BENT GRASS EAST COMMERCIAL
FILING NO. 3
STREET SECTIONS / EROSION CONTROL NOTES

BENT GRASS EAST COMMERCIAL FILING NO. 3 STRIPING PLAN			
DESIGNED BY	PRA	SCALE	DATE 03-16-21
DRAWN BY	PRA	(H) 1" = 30'	SHEET 5 OF 8
CHECKED BY	(V) 1" = N/A	JOB NO.	2177.64

BENT GRASS EAST COMMERCIAL FILING NO. 3 PEDESTRIAN RAMP DETAILS			
DESIGNED BY	PRA	SCALE	DATE 03-16-21
DRAWN BY	PRA	(H) 1" = 10'	SHEET 6 OF 8
CHECKED BY	(V) 1" = N/A	JOB NO.	2177.64

Construction Drawings_v1 redlines.pdf Markup Summary 1-11-2022

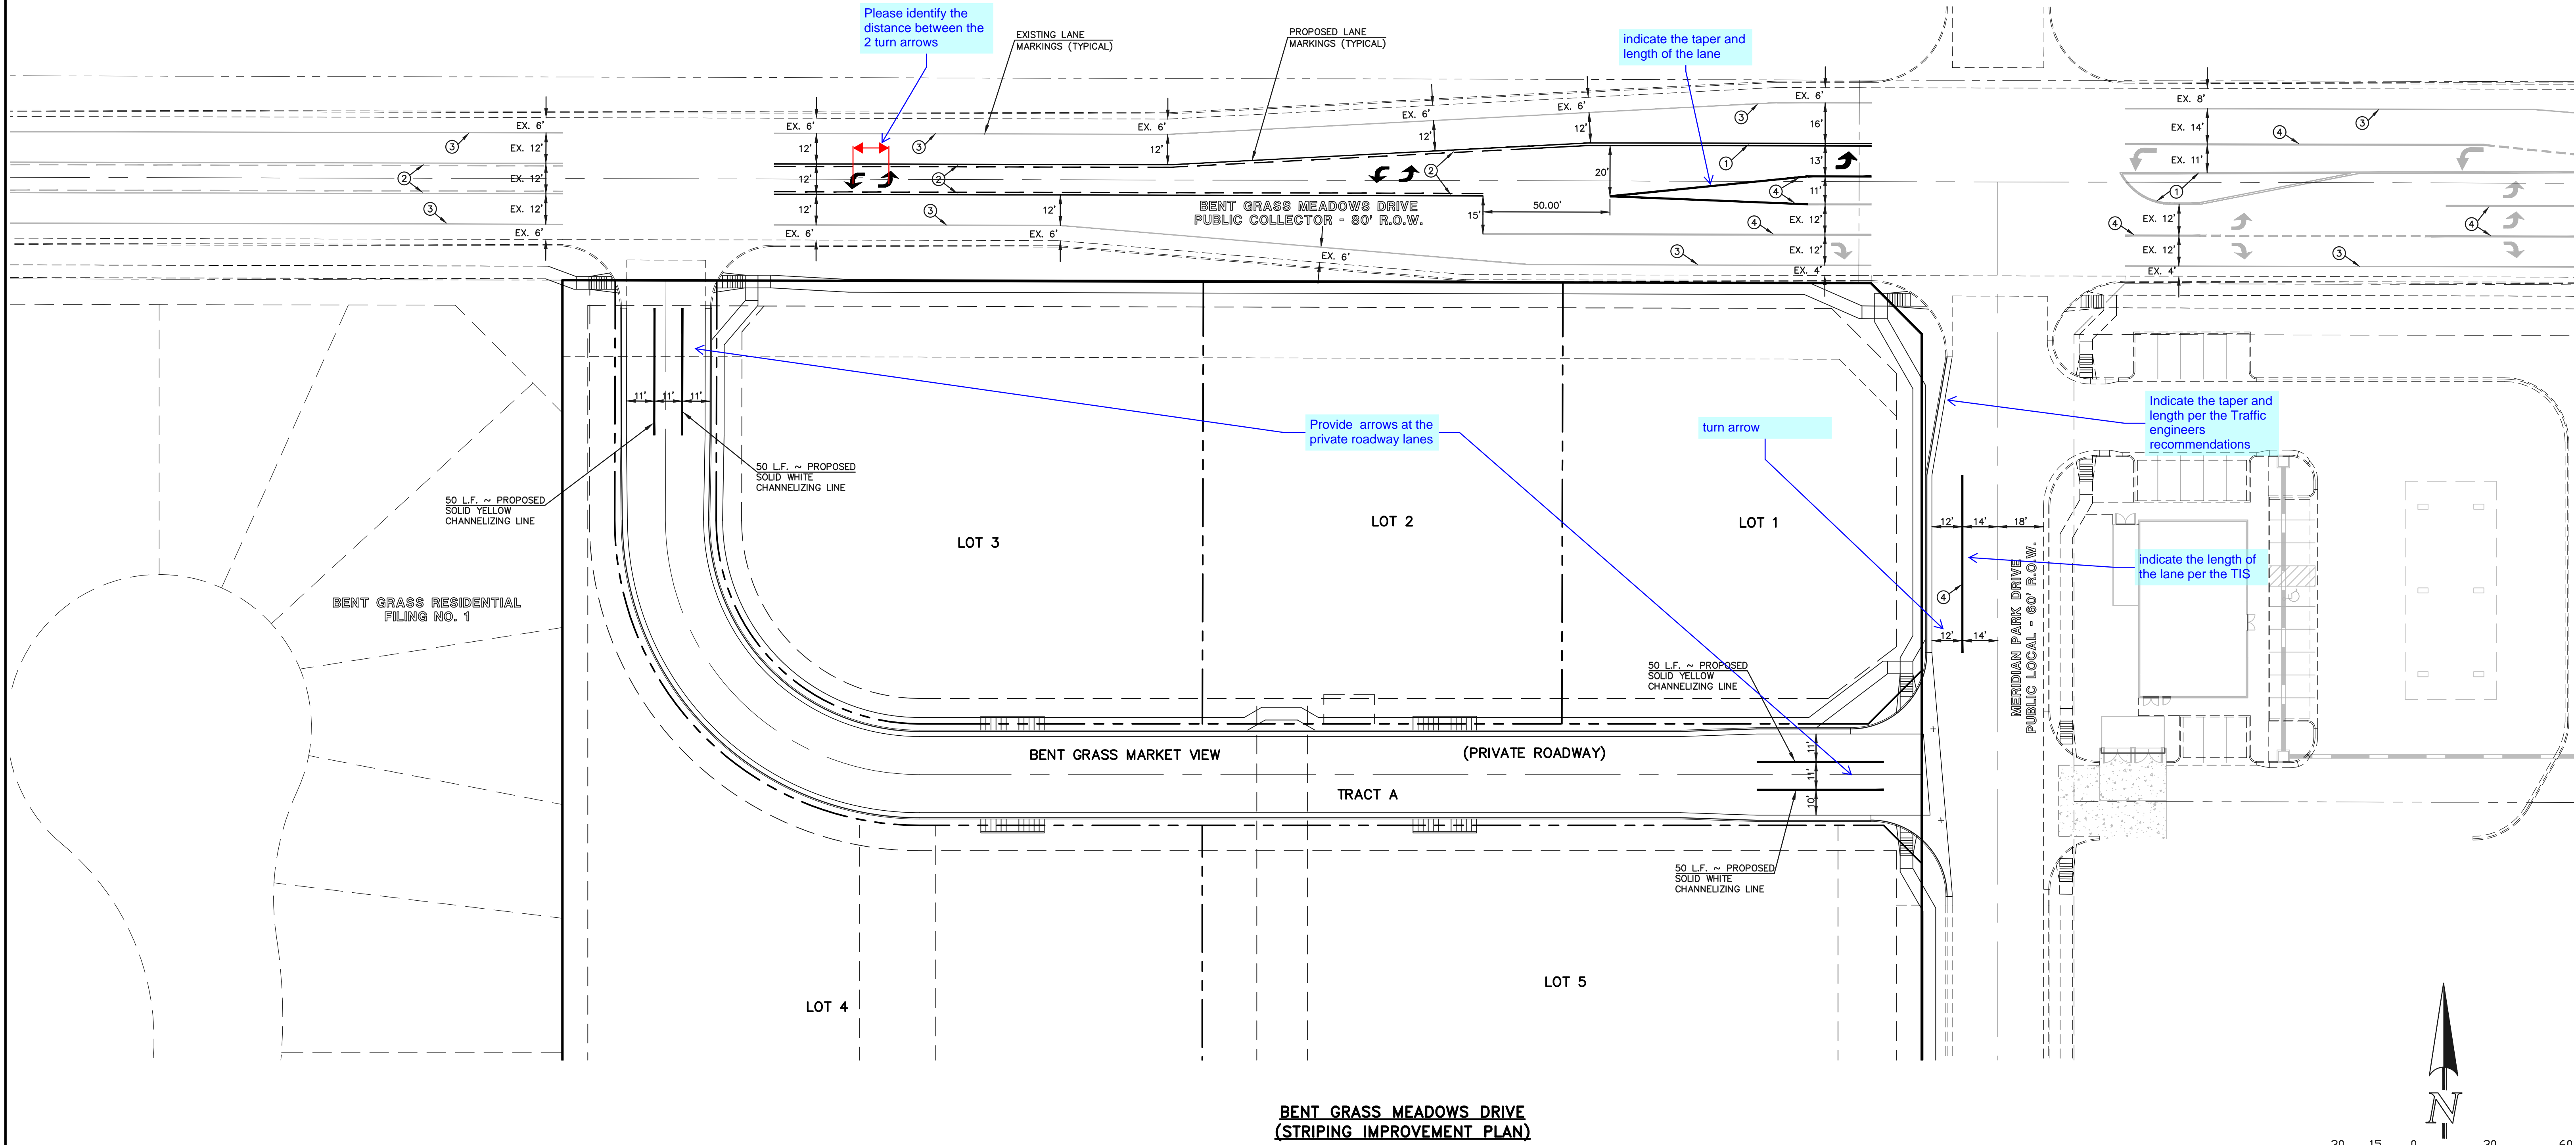
Shall be 4' apart per CDOT standards (S-627-1)

per County standard notes turn arrows shall be 125 mil. Please revise

Indicate the taper and length per the Traffic engineers recommendations

Indicate the length of the lane per the TIS

**INTERSECTION OF
BENT GRASS MEADOWS & BENT GRASS
MARKET VIEW (PRIVATE ROADWAY)
'RAMP DETAIL-01'**

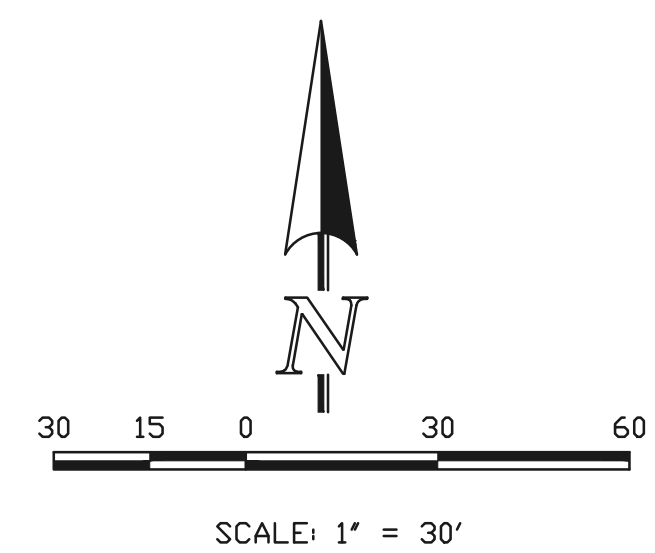
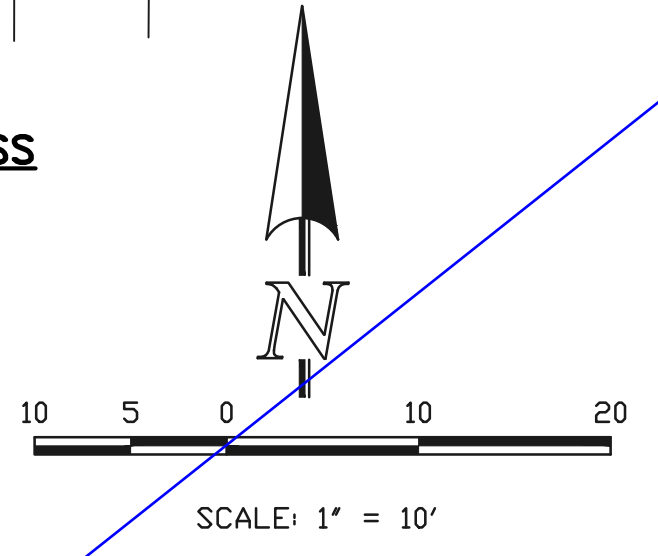
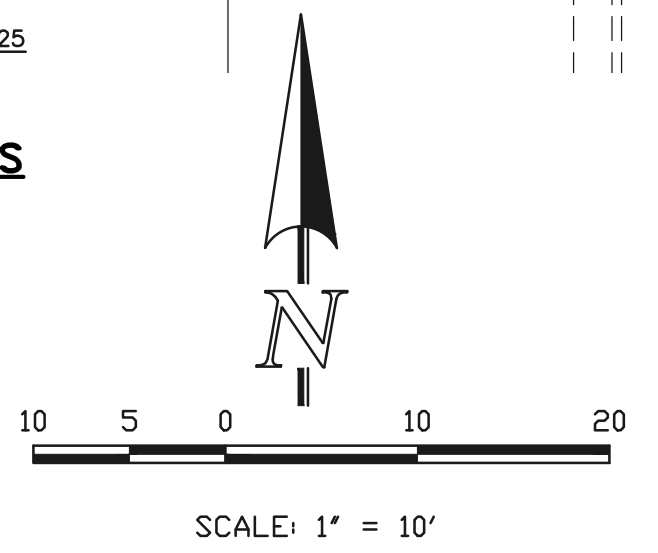
Please provide the cross slope. Per the grading plan it appears that it may exceed 2% max criteria indicated in ECM 6.3.2 Figure 6-9

provide spot elevation

per ECM 6.3.1.G.5, The slope of the landing in any direction shall not exceed 2%. Please verify that all landings meet this criteria and revise accordingly.

FYI: Should this slope exceed 5% in the field, edge protection per ECM 6.3.1.G would be required. Consider reducing the slope% to allow for construction tolerance

Please label the cross slope
